D C3D.dwg – Layout Tab: C1.0 TITLE SHEET

THE VILLAGES AT
GRANTS FR
SECTION TWO, BL
MILITARY SURVE
VILLAGE OF SOU
WARREN COU

Drawing:	11C009-003 CD C3D
Drawn by:	TAC
Checked By:	GJK
Issue Date:	03-11-15
Sheet:	C2.0

STANDARD NUMBER
W-10

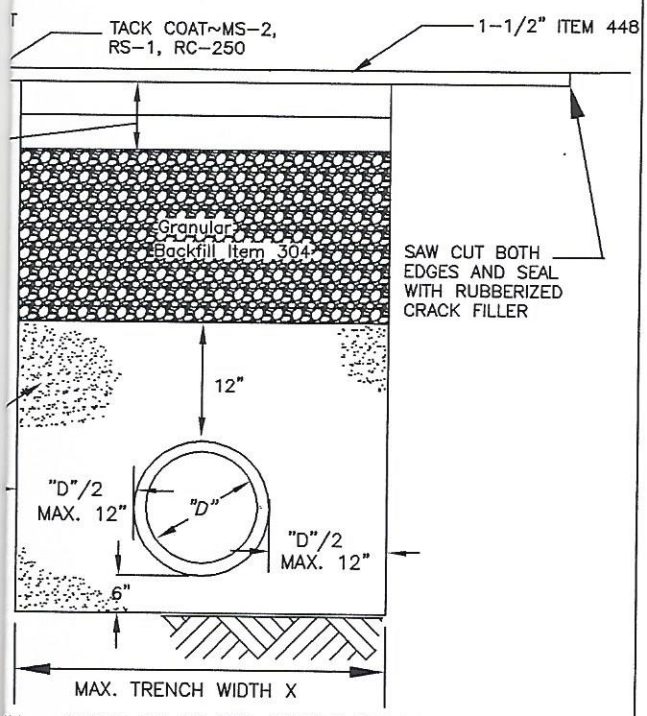
Two?
